ADA Curb Ramp New Construction Inspection Form (Parallel)

NW Timeric

23885.56

NW Belgium

PARALLEL RAMP (PL)

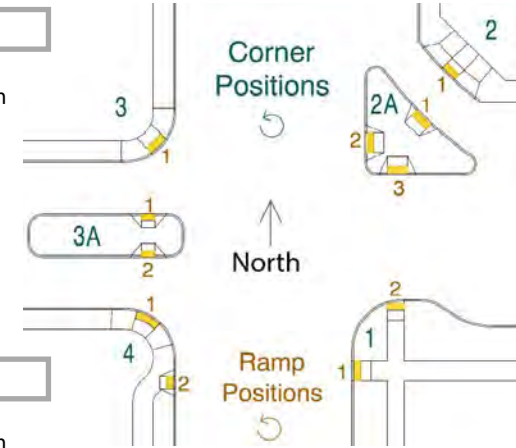
$\leq 1/4"$ ☐ $> 1/4"$ ☒

☐ 9.92 $\leq 8.3\%$ ☐ $> 8.3\%$ ☒

0.8 $\leq |5.0\%|$ ☐ $> |5.0\%|$ ☒

3.9 $\leq 2.0\%$ ☐ $> 2.0\%$ ☒

3.3 $\leq 2.0\%$ ☐ $> 2.0\%$ ☒

3.45 $\geq 4.0'$ ☐ $< 4.0'$ ☒

NTD Fail RR 1 And TS
